**Consumers
Power
Company**

February 20, 1975

Re: Docket 50-255
License DPR-20
Palisades Plant

RESPONSES TO USNRC
Request of February 4, 1975
for Additional Information

'B' STEAM GENERATOR

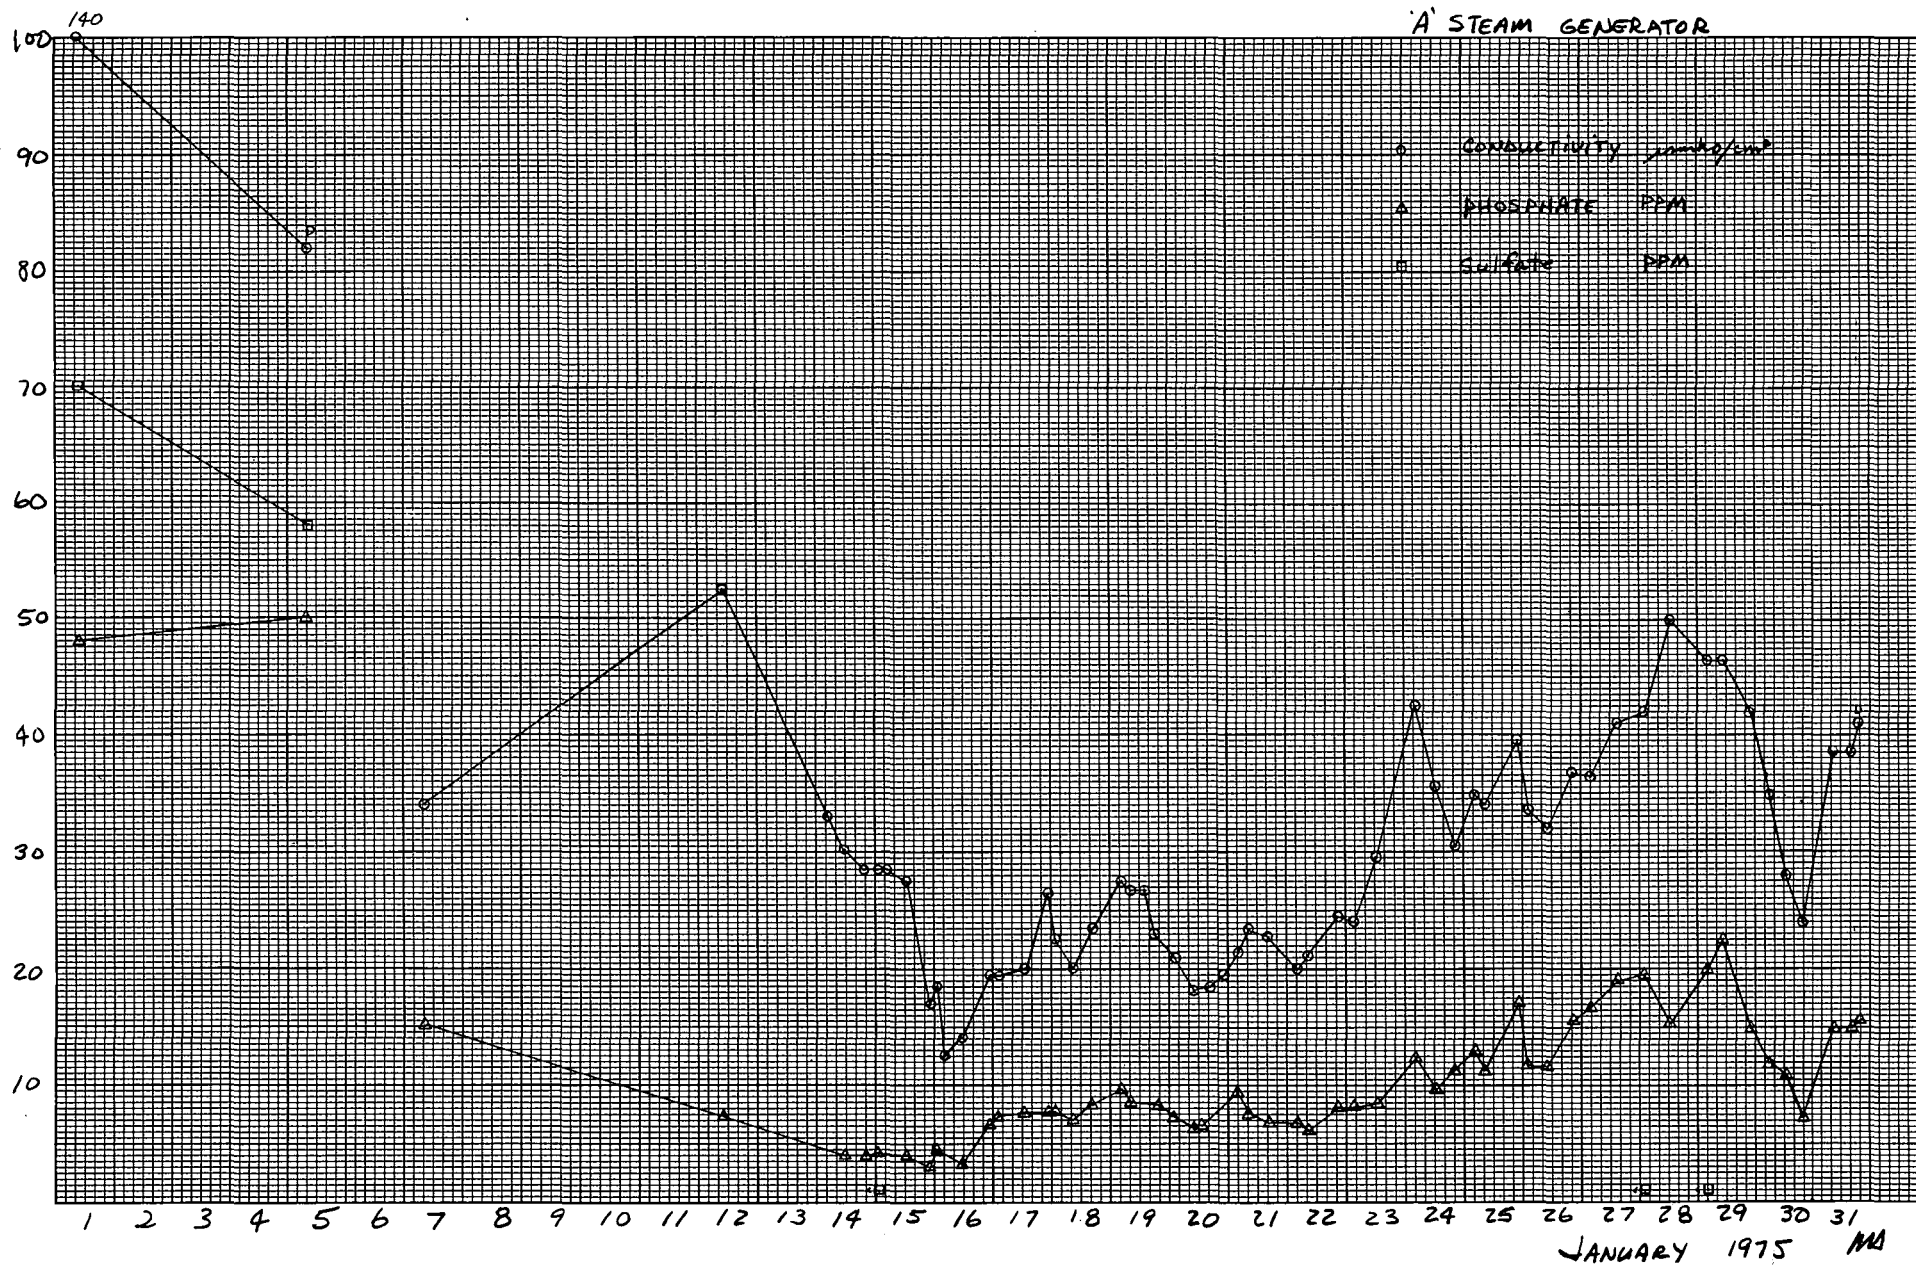
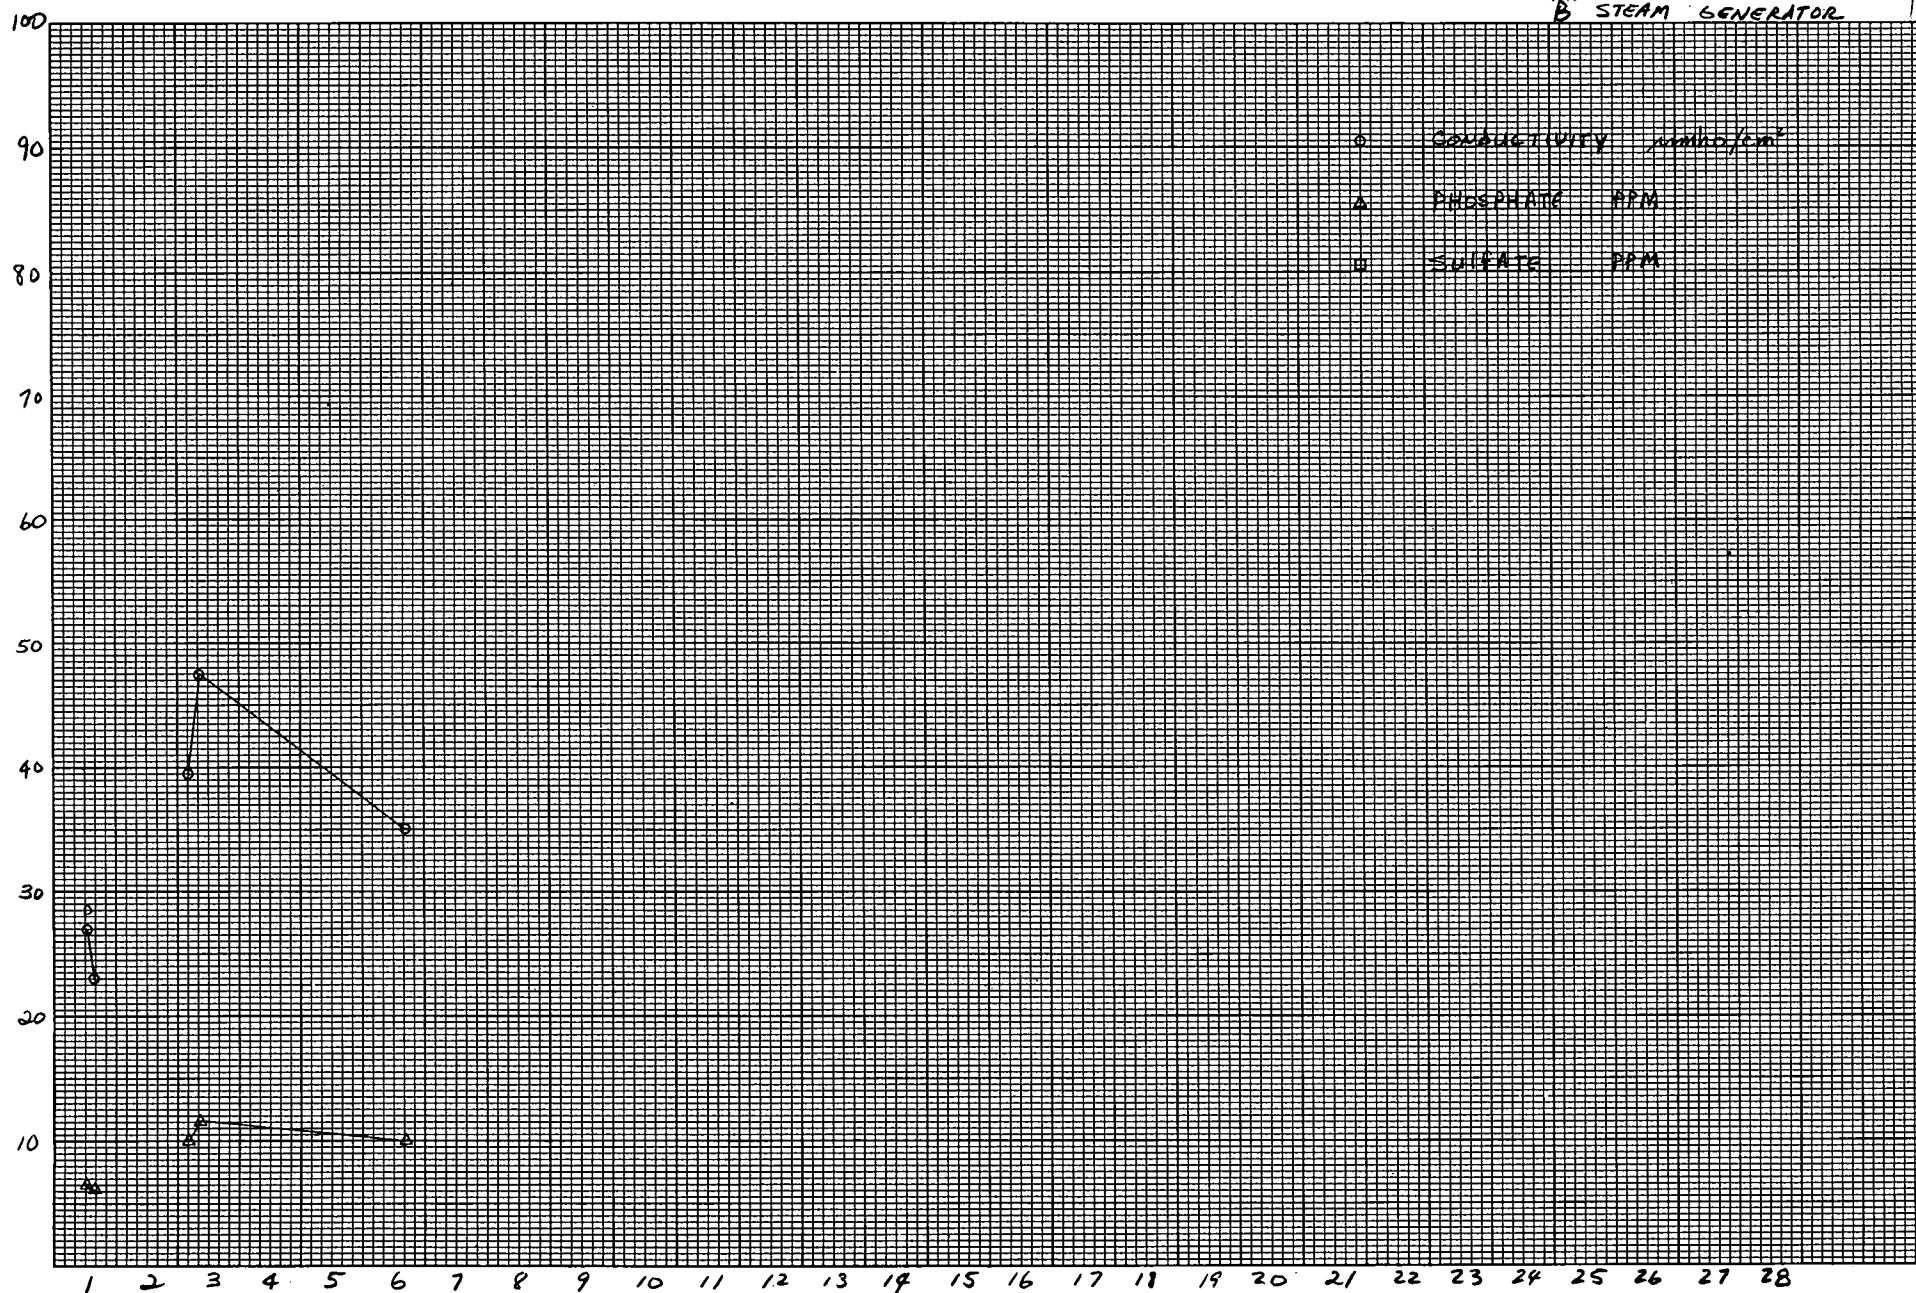
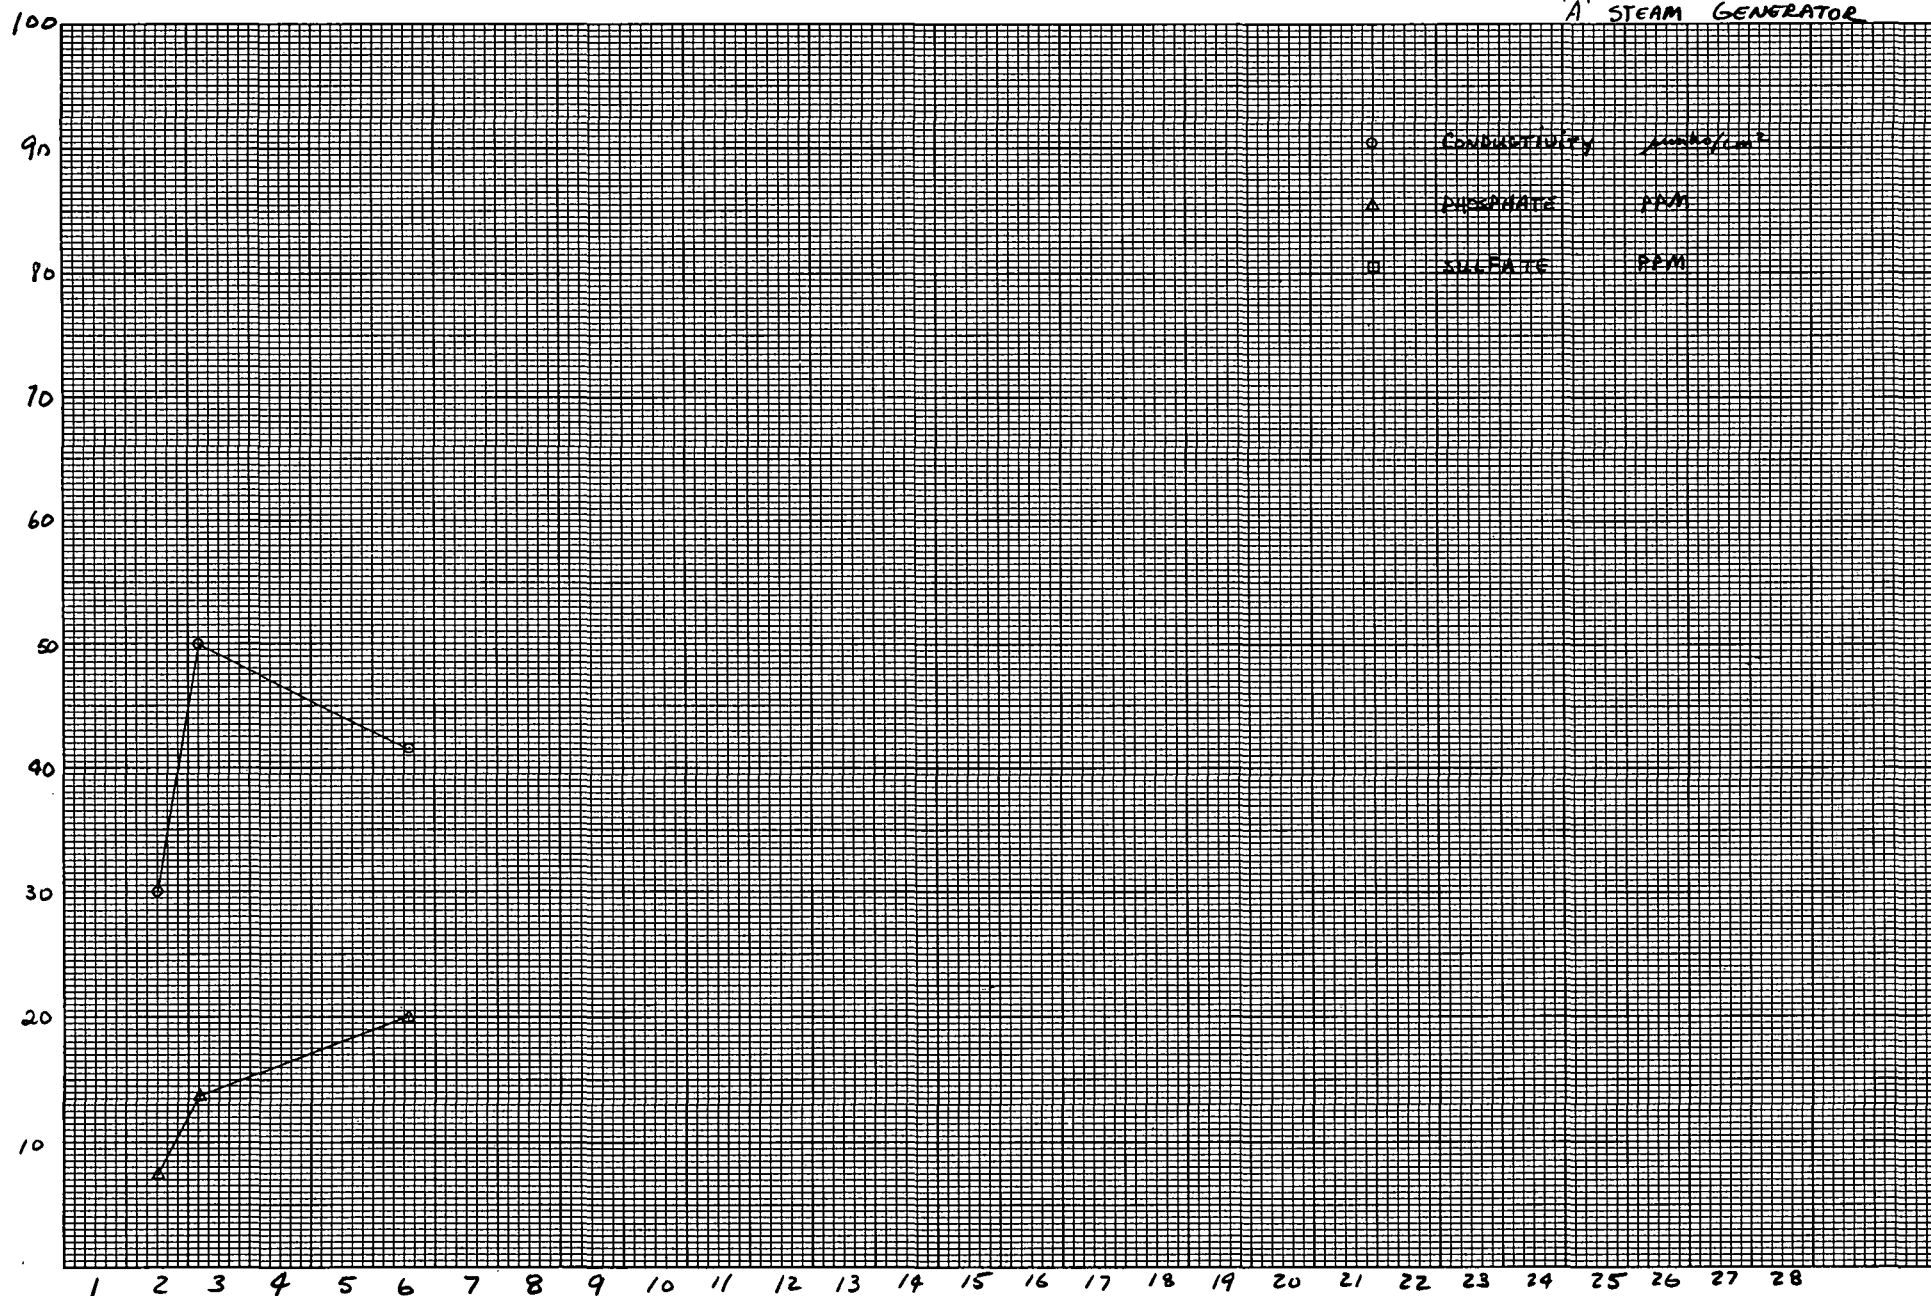
Question 6

"Provide a graph or plot showing the following as a function of time for both steam generators from the onset of isothermal flushing operations to the present:

- a. Phosphate and sulfate concentration,
- b. pH and,
- c. pounds of phosphate and sulfate removed.

The attached graphs, supplemented by the notes listed below, are provided in response to this request.

Notes

1. The letter "D" on several of the graphs indicates a sample (generally a composite) taken during a generator drain.

2. The first accounting of total PO_4 and SO_4 removed from the generators took place in early September; however, due to the error noted late in September with the PO_4 analysis, the total PO_4 removed starts in October. Quite a lot of work would be required to go back and add up the results for the missing four data points (September) and, therefore, it was not done.

3. Due to circulating water leakage (high in SO_4) after October 1, 1974, the pounds of sulfate removed from the generators were no longer calculated. It would be impossible to determine whether we are removing sulfate from the "old sludge" or from the "new sludge" caused by condenser leakage.
